# Addendum No. 7 to Contract Documents

Project	Biosolids Process Improvements	CWSRF Project No.	C7-6240-13-00
Owner	The City of Auburn		
Contract No.	BPI-1A General BPI-1B Heating and Ventilation BPI-1C Electrical BPI-1D Plumbing	Date	January 13, 2023

**January 13, 2023**

1 NORTH ELEVATION  
A-30-101 SCALE: 1/8" = 1'-0"

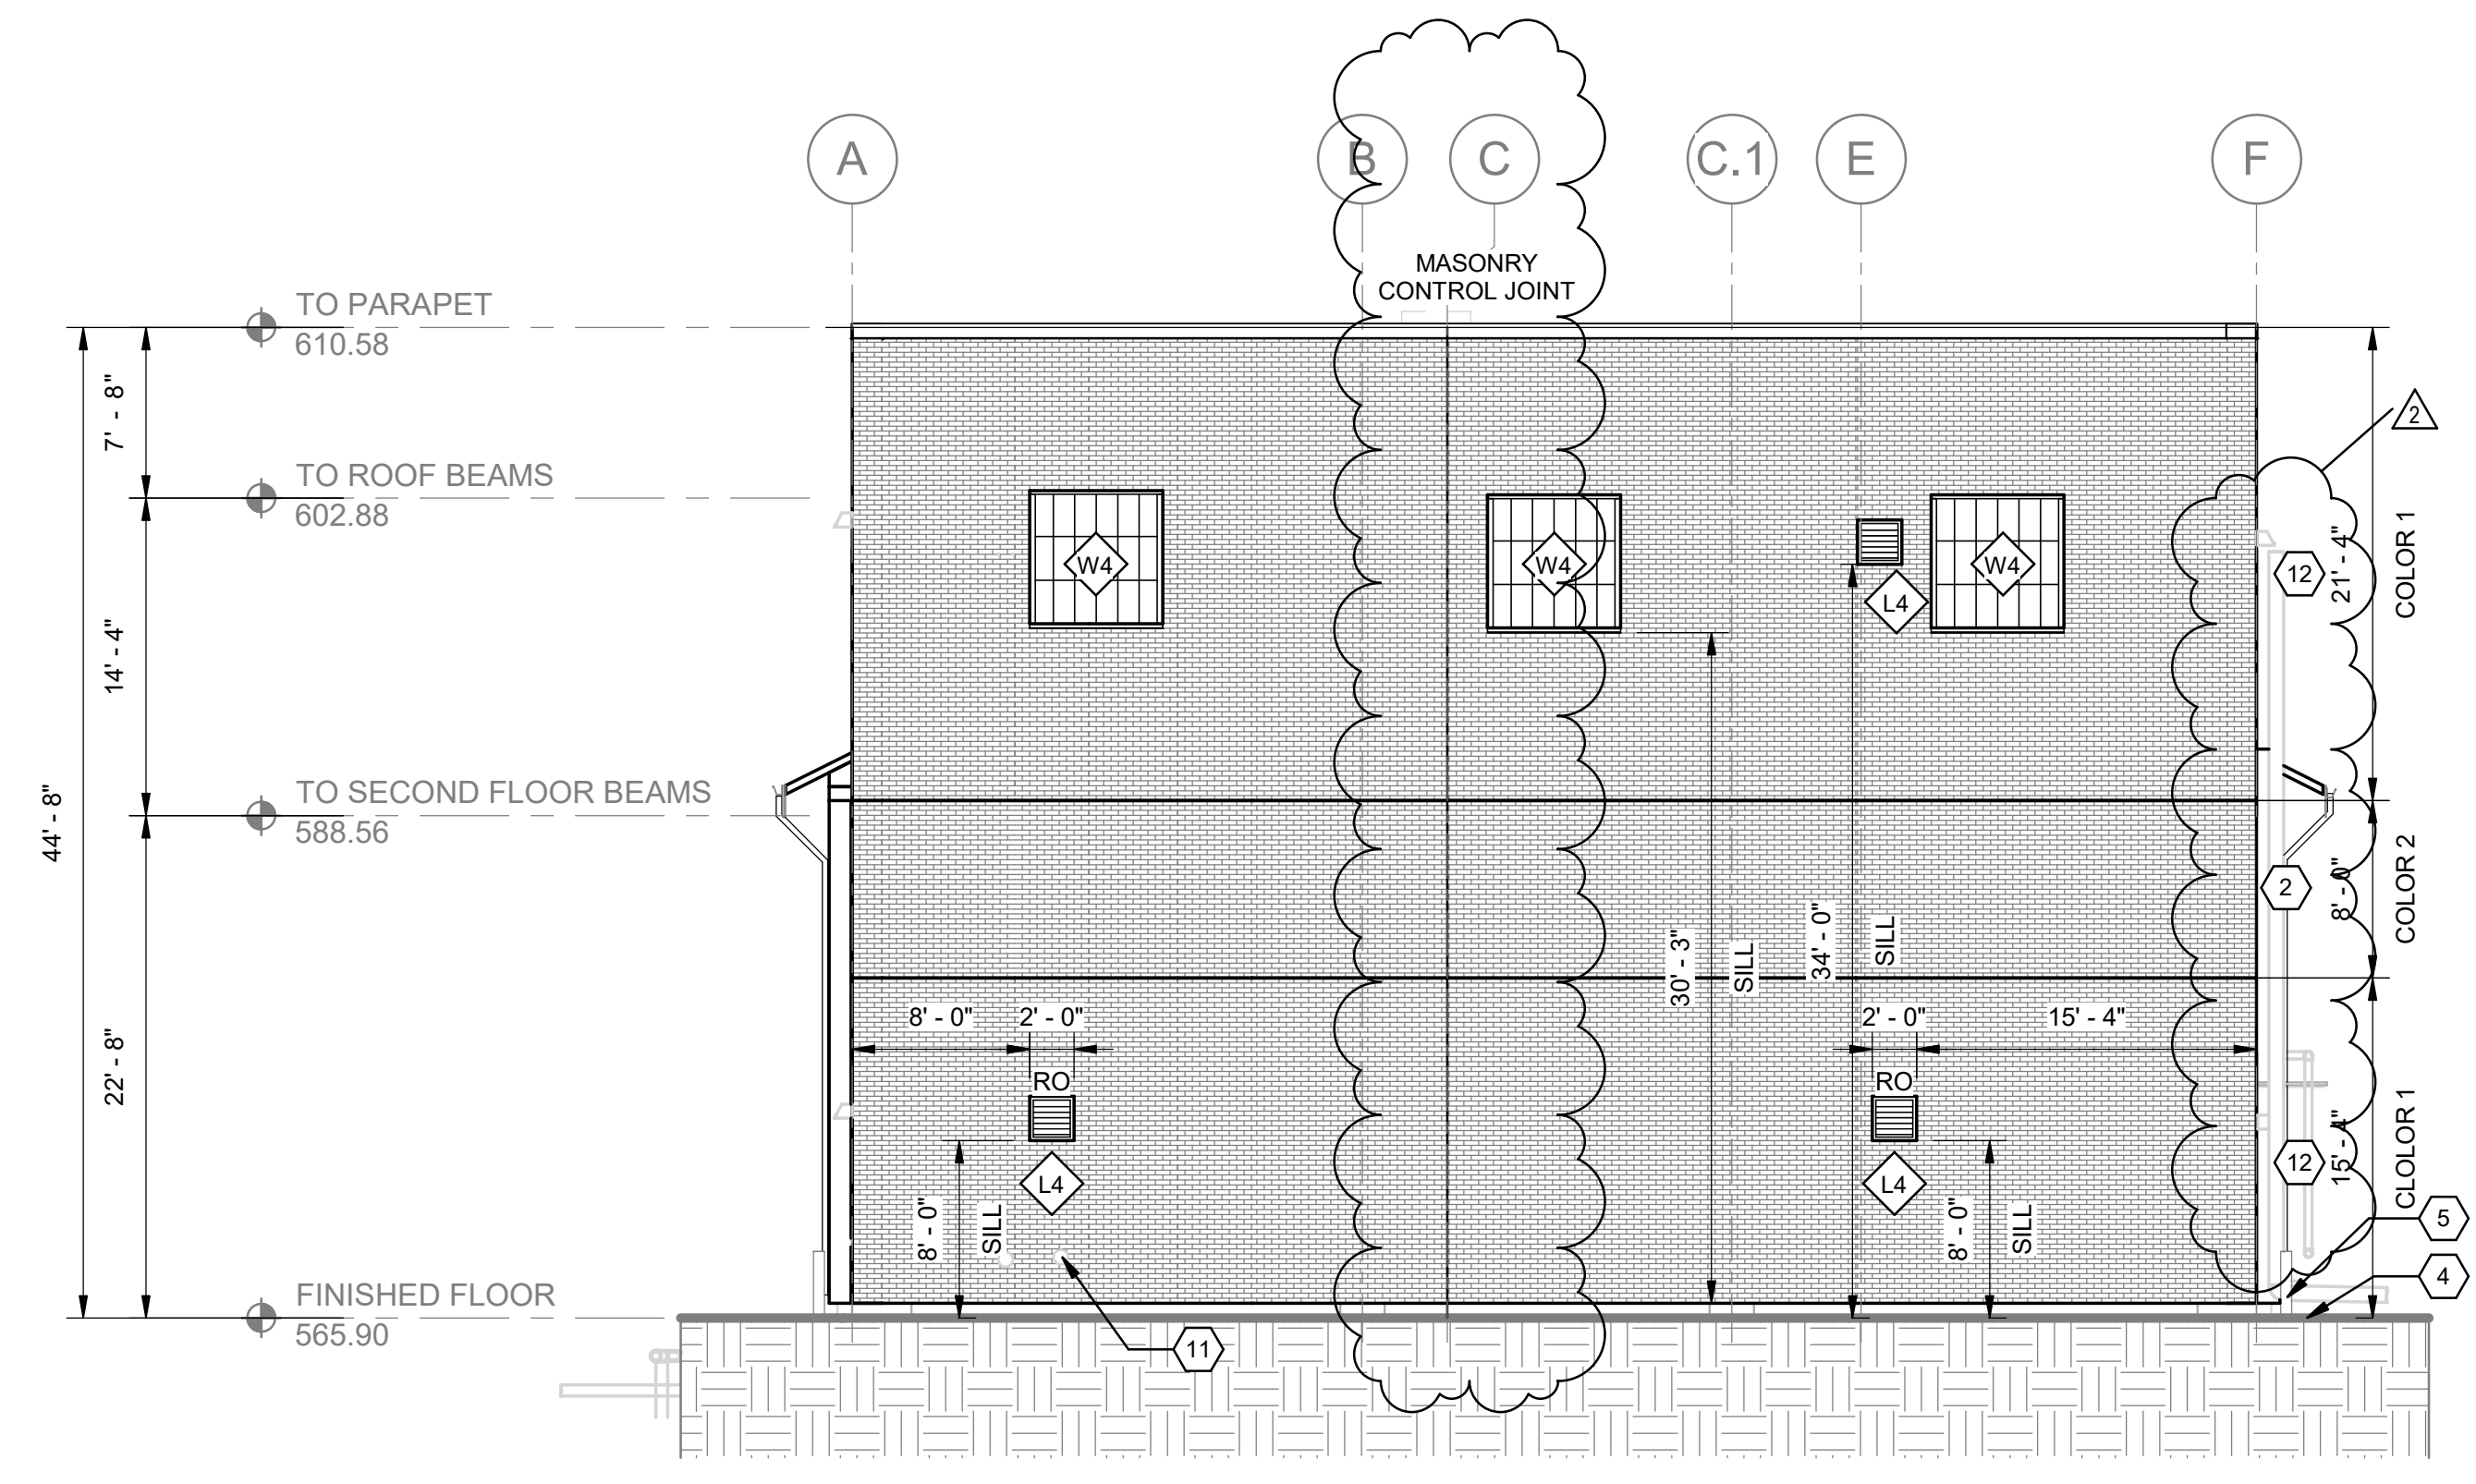
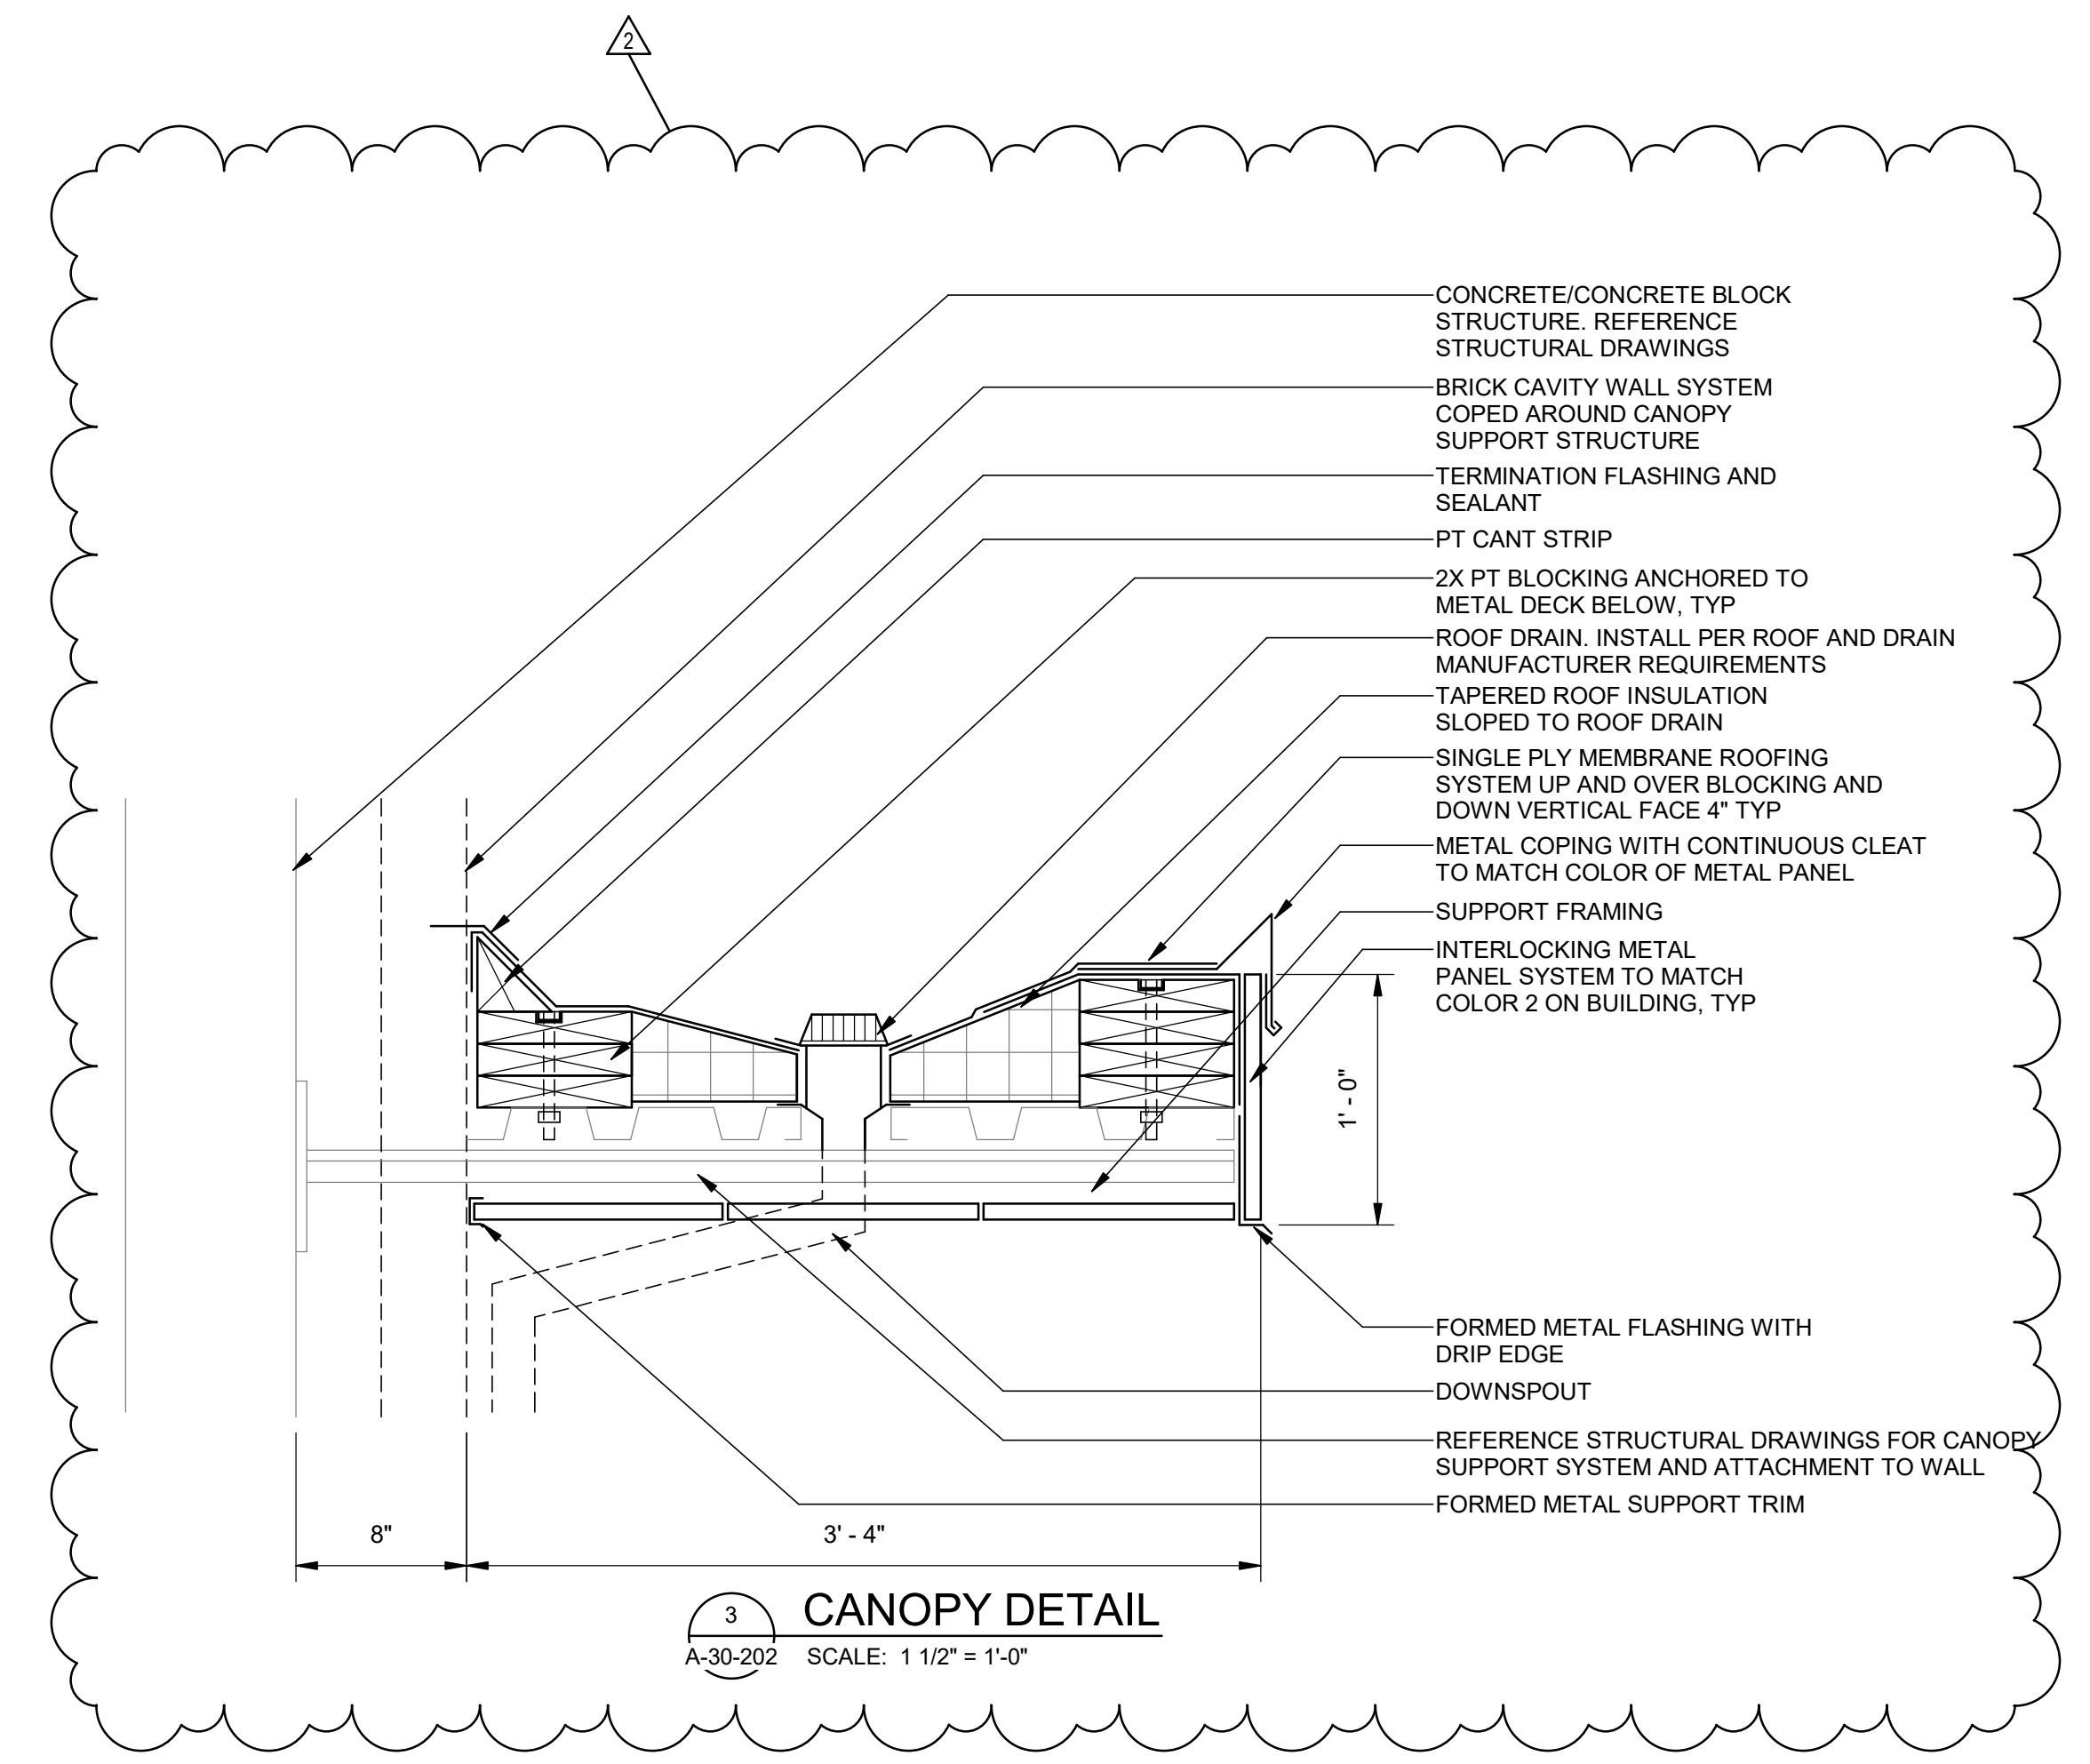
- 12 BRICK VENEER, COLOR 1 TO MATCH LIGHT TAN COLOR OF EXISTING SOLIDS HANDLING BUILDING ON SITE
  - 13 CANOPY STRUCTURE APPROXIMATELY 3'-4" WIDE X 1'-0" DEEP X 20'-0" WIDE. REFERENCE DETAIL 3 ON A-30-202. REFERENCE STRUCTURAL DRAWINGS FOR MORE INFORMATION.
